WOLLONGONG CITY COUNCIL

Local Transport Forum Minutes

9 June 2026

Item 4.1 - HUNTLEY, Cleveland Road - Cleveland Road Upgrade

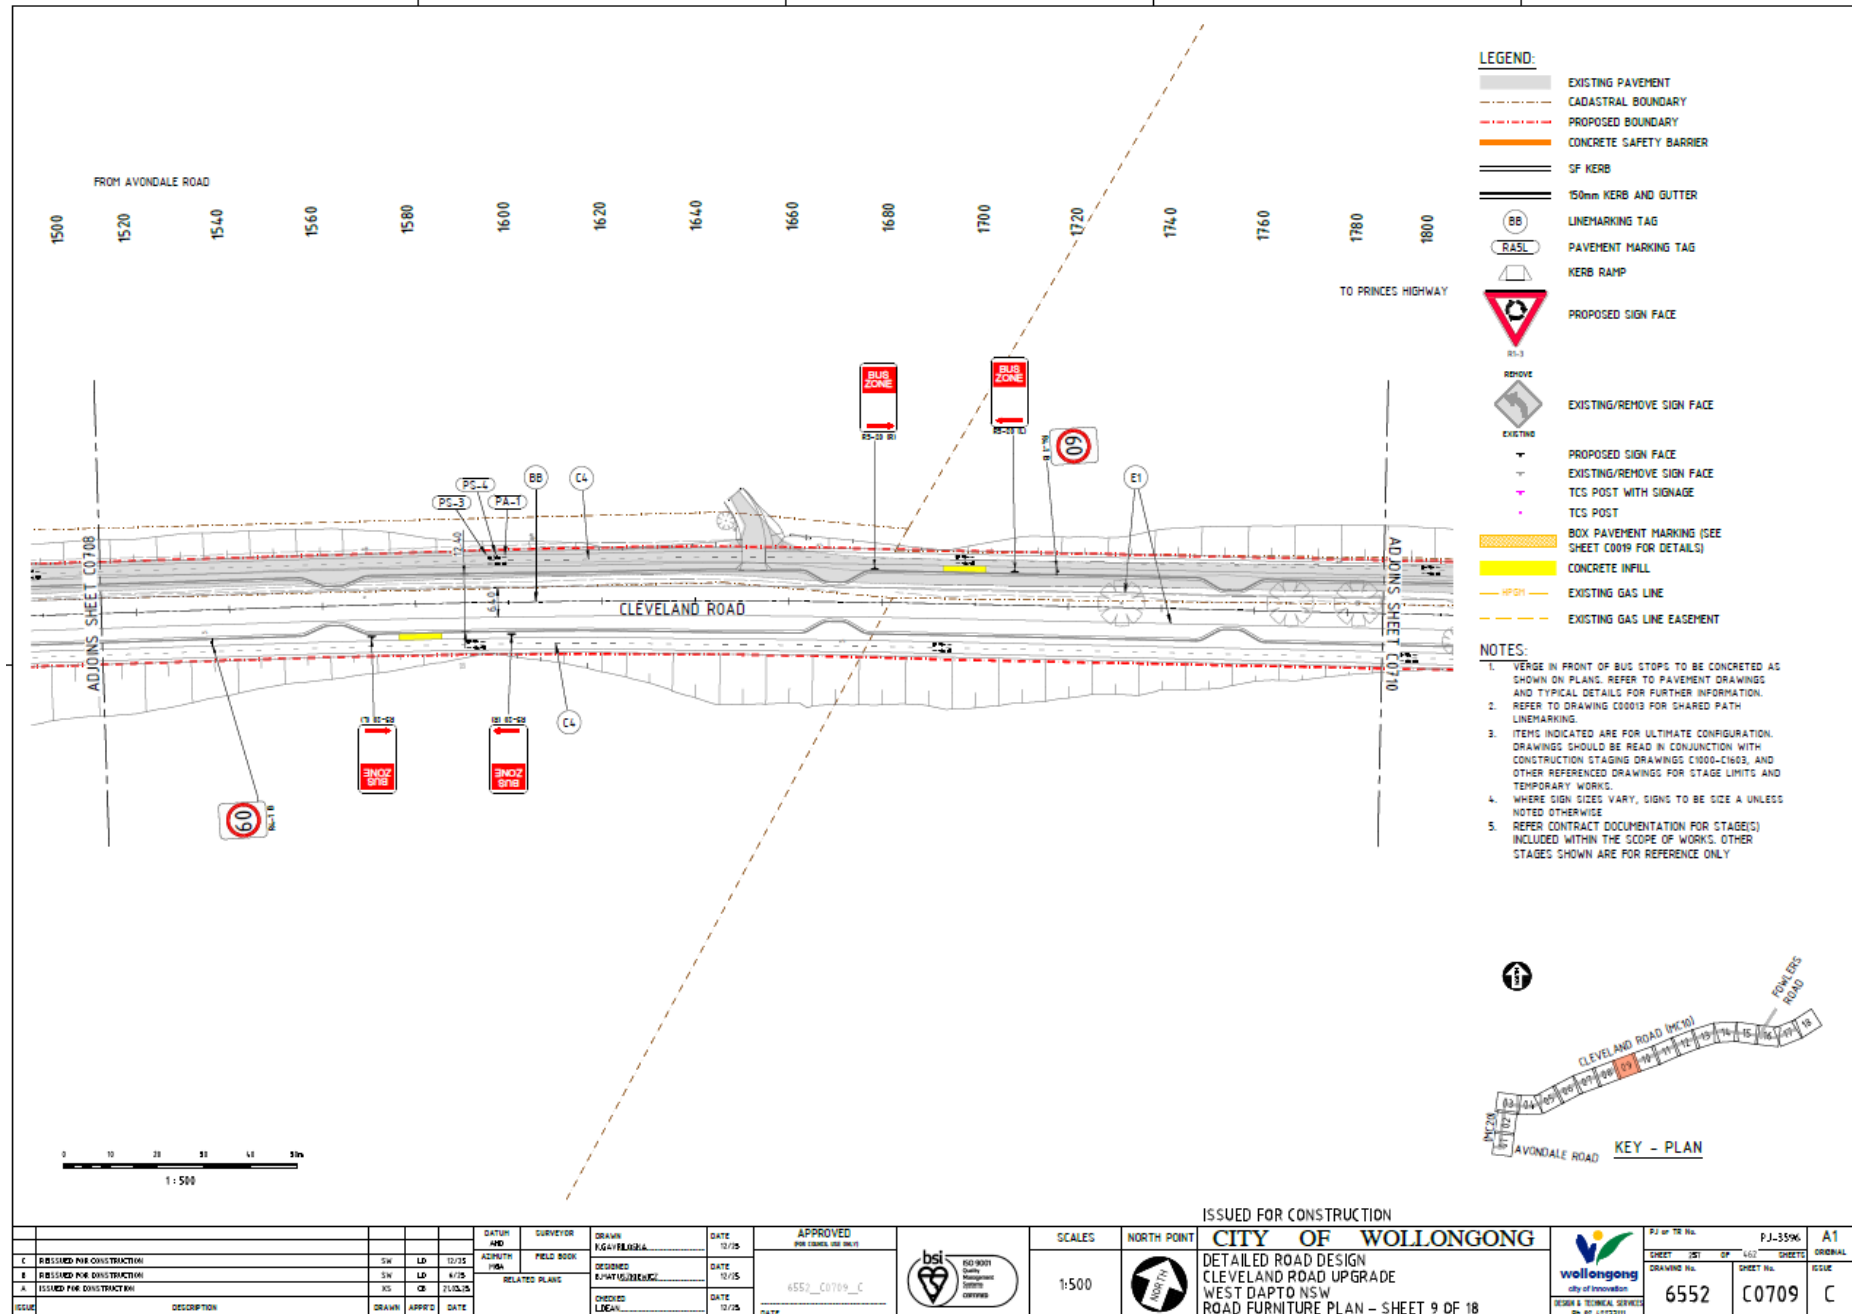
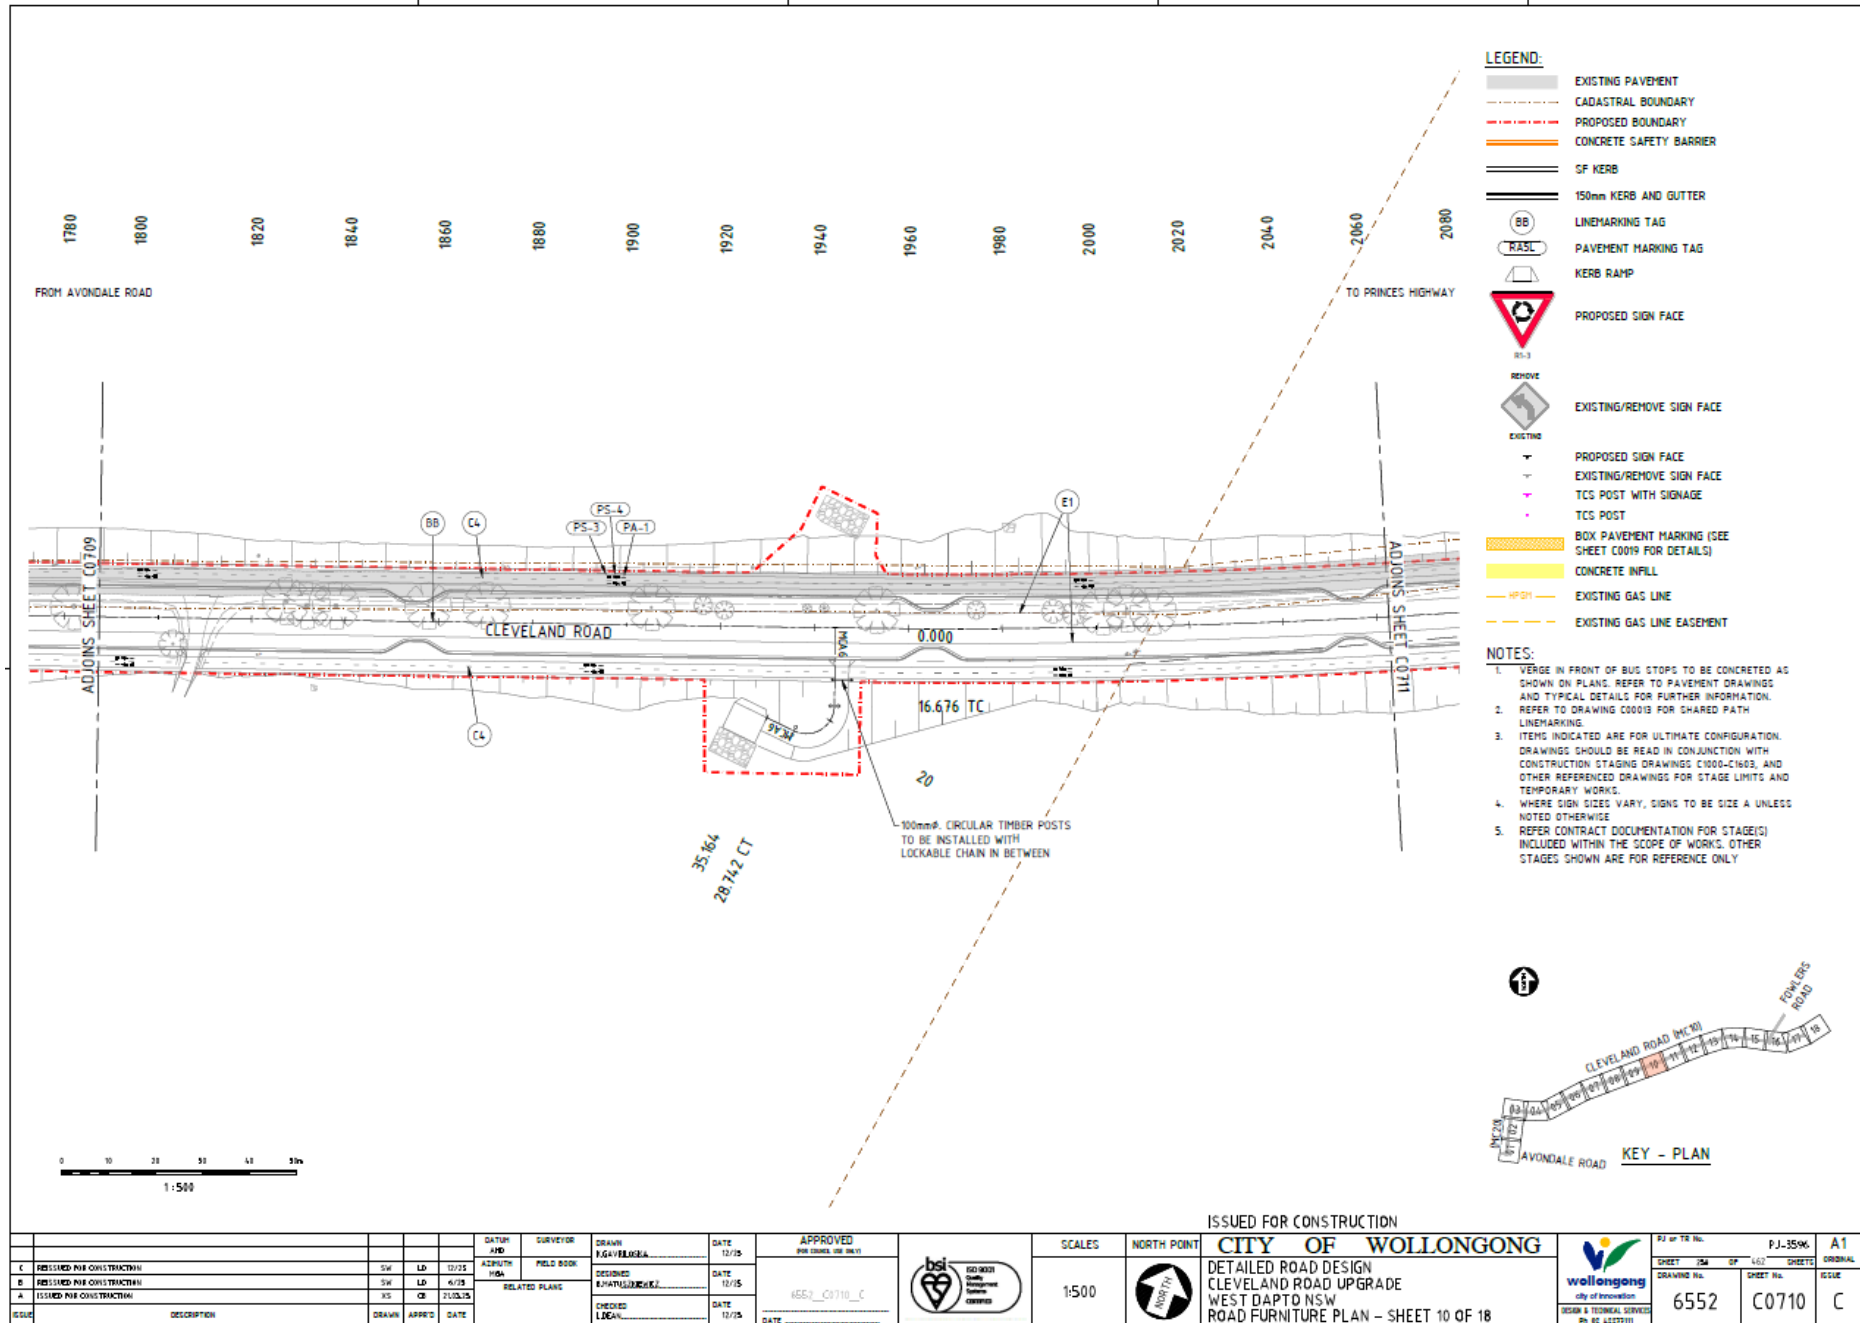
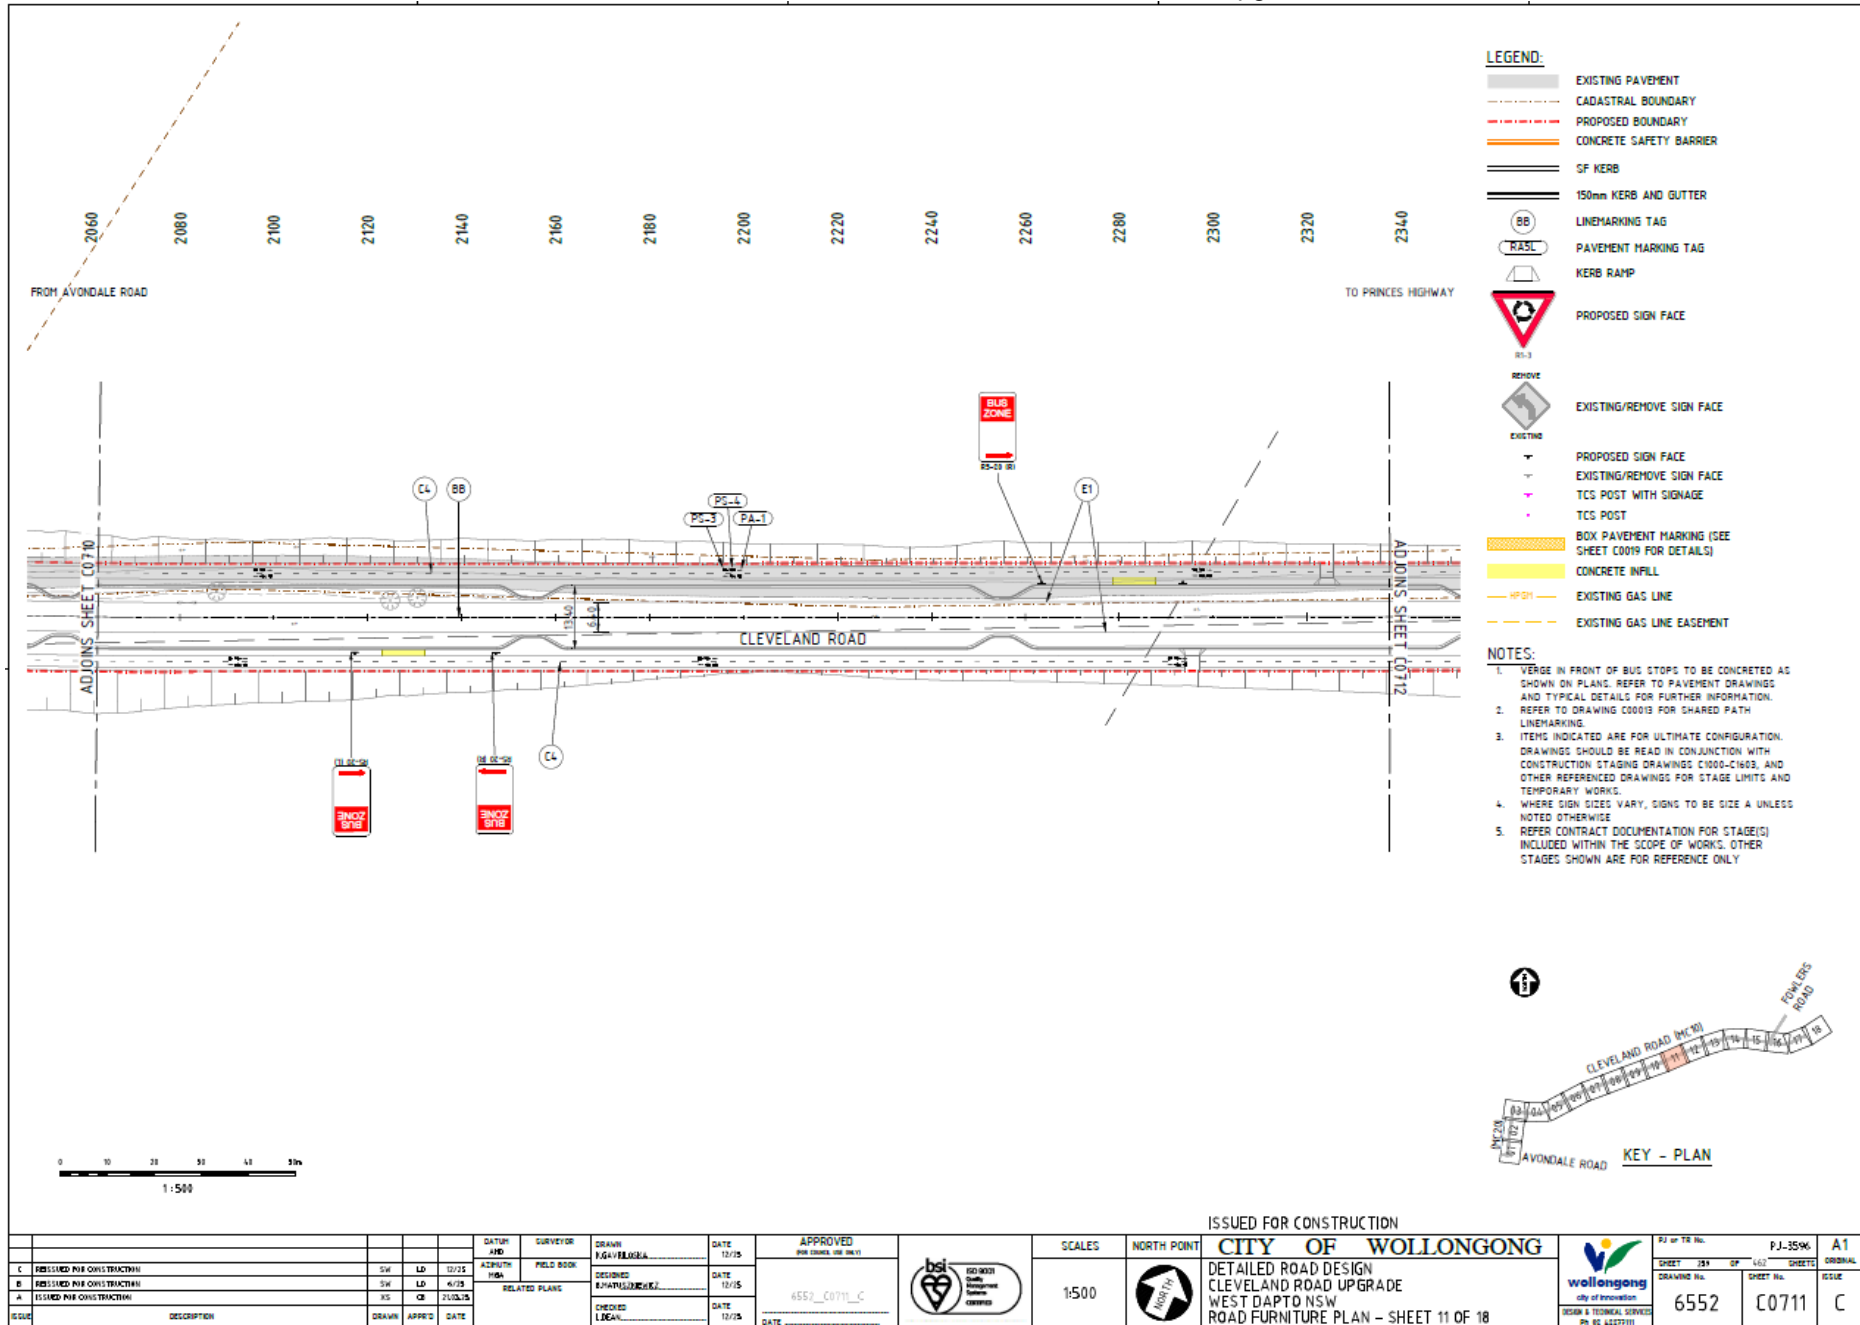
Forum Member /Guest	Advice	Council Comment
TfNSW	a) There is no proposed widening of the shared path at bus stop locations. There is likely to be conflict between people waiting for the bus and shared path users. This risk is expected to increase given the corridor functions as a movement route, with higher bicycle travel speeds likely. It is recommended that the shared path be widened at bus stops to improve separation between waiting passengers & path users, consistent with council standard drawings & TS 04951.4. b) P26/C0709 – bus zone prior to kerb extension westbound c) P28/C0711 –bus zone sign eastbound is missing and requires an R5-20(L) sign. d) P33/C0716 – No Stopping at the wombat crossing. T-intersection warning signage may be warranted e) P37/C0701 – speed zone sign located within a bus zone. Consider advanced warning signage for the Avondale Road roundabout. Transition from 80 km/h to 50 km/h suggests advance warning would likely be beneficial (AS1742.2, Section 2.6.4) f) P39/C0703 – possible drafting error over bridge (grey rectangle)	a) Proposed bus zones are temporary. Ultimate locations are identified through relevant DA processes. Condition #1 added to ensure temporary and final bus stops will be DSAPT compliant. b) These are calming points (not crossing points). c) Condition #2 added d) Condition #3 added. e) Condition #4 added. f) Plans to be adjusted to remove error.

The interim and ultimate staged Plans 6552-SK8001-DRG-RD01, 6552-10-C1205, 6552-10-C1301-C1302, 6552-C0707-C0716 (interim) and 6552-C0701-C0761 (ultimate) be approved subject to:

1. All proposed bus zones to be designed in accordance with Councils minimum standard drawings including, but not restricted to, managing conflicts between shared path users and public transport users.

2. Eastbound Bus Zone on plan P28/C0711 having a close sign to end the zone. An R5-20(L) sign is required.
3. Plan to be reviewed to determine whether additional no stopping signs/lines and intersection warning signs are required adjacent to wombat crossings and on approach to intersections in accordance with relevant Standards
4. Relocate proposed speed zone sign to before the bus zone sign (in the no stopping zone) and install roundabout warning signs on approaches to the roundabout on Avondale Road in accordance with AS1742.2, Section 2.6.4.

Item 5.1 - KEMBLA GRANGE, 441 Princes Highway – Signs and Lines for Housing Estate

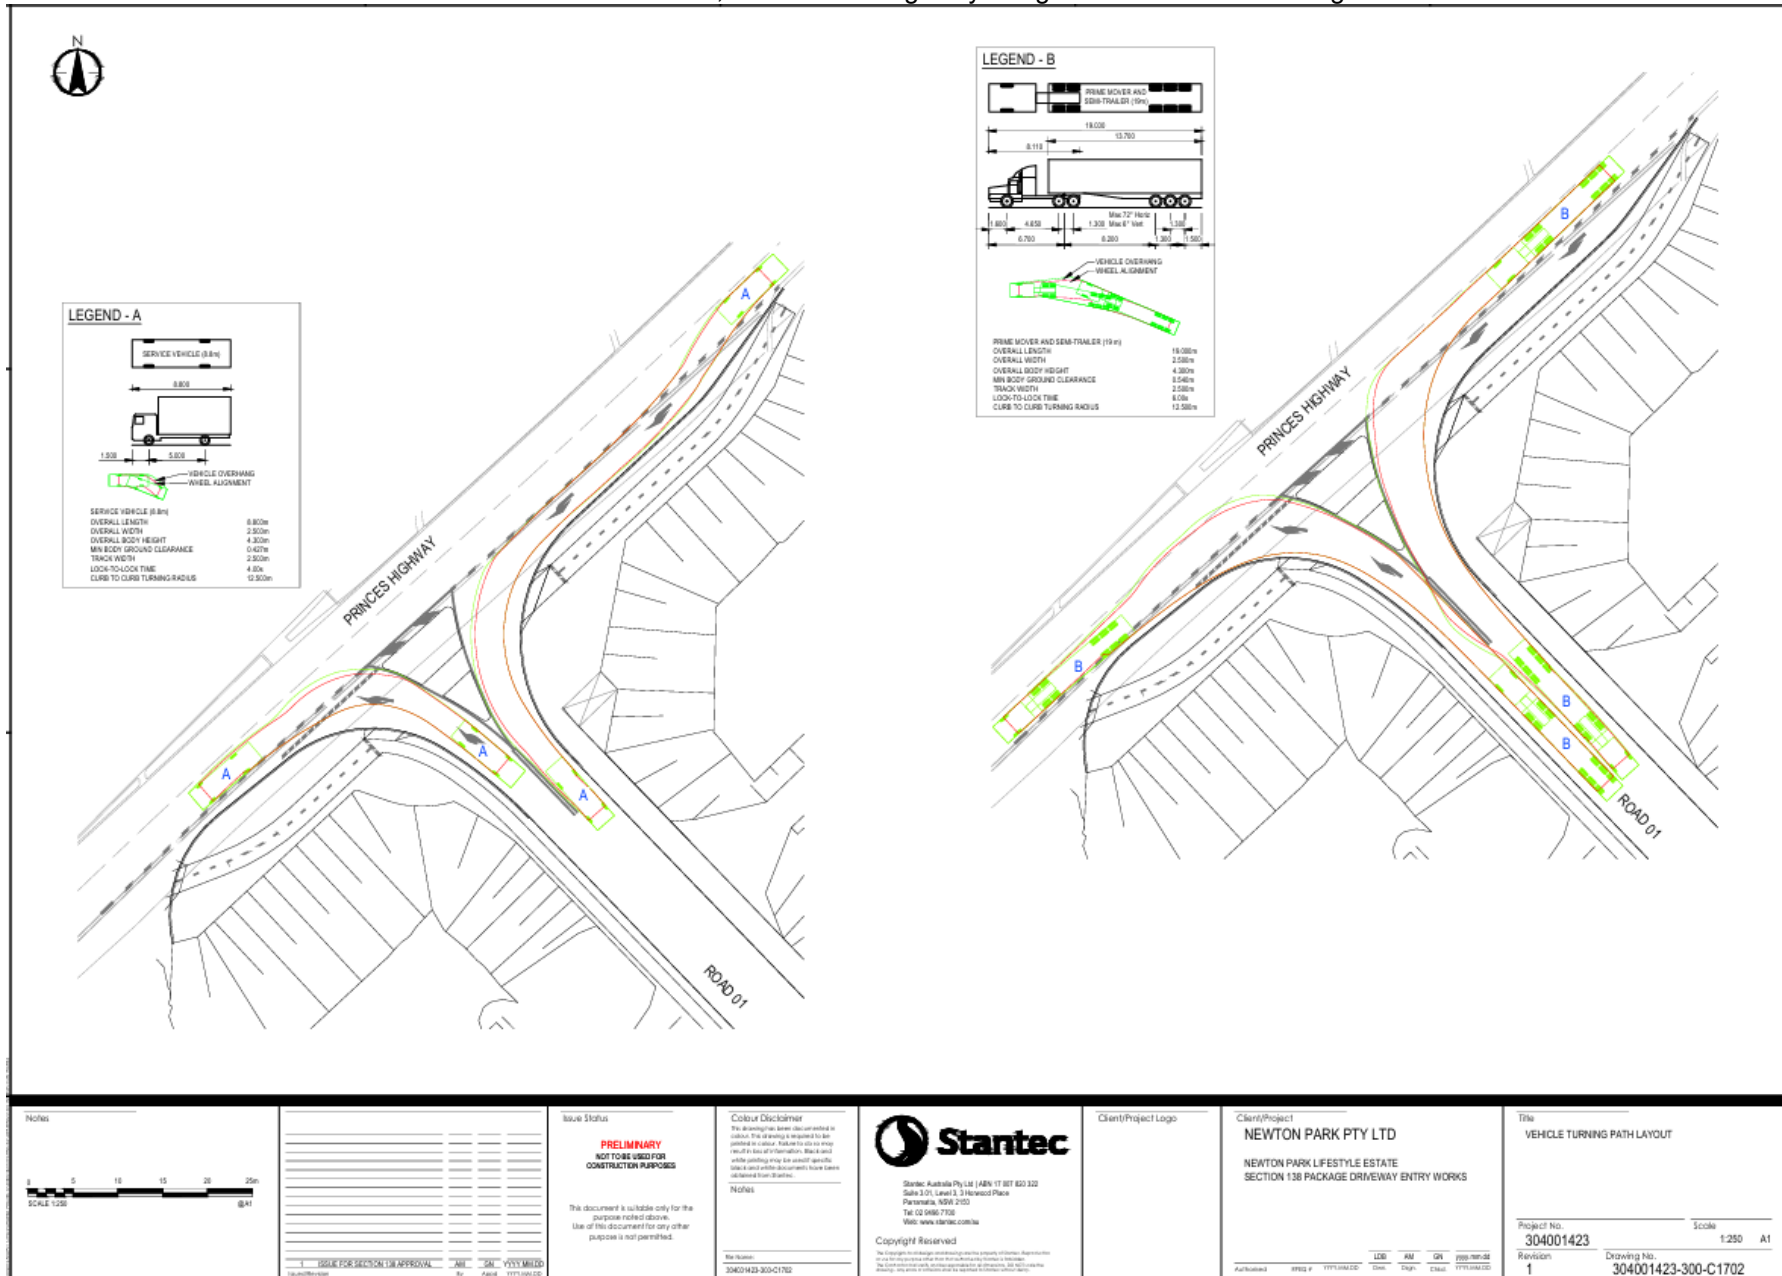
Forum Member /Guest	Advice	Council Comment
TfNSW	a) TfNSW supplement to AS1742.10 requires that all signage and line marking for priority crossings align with AS1742.10 including the use of W8-32. Please amend plans to ensure consistency b) Zig zag line marking on the exit approach may not be necessary, however this can be left to Council to assess and determine as part of detailed design.	a) Condition 1 added b) Condition 2 added

The sign and linemarking plan be approved subject to:

1. W8-32 sub-plates being installed under Give-Way signs in accordance with Transport for NSW supplement to AS1742.10. Further, warning signs on approach to the crossing must also be updated to W6-14-1.
2. Proposed zig-zag linemarking in northbound direction to be reviewed in accordance with relevant standards to confirm whether linemarking is required. If not required, zig-zag linemarking on the northbound approach (straight section of road only) is to be removed. Zig-zag lines on the left turn lane around the bend entering the subdivision is to remain.
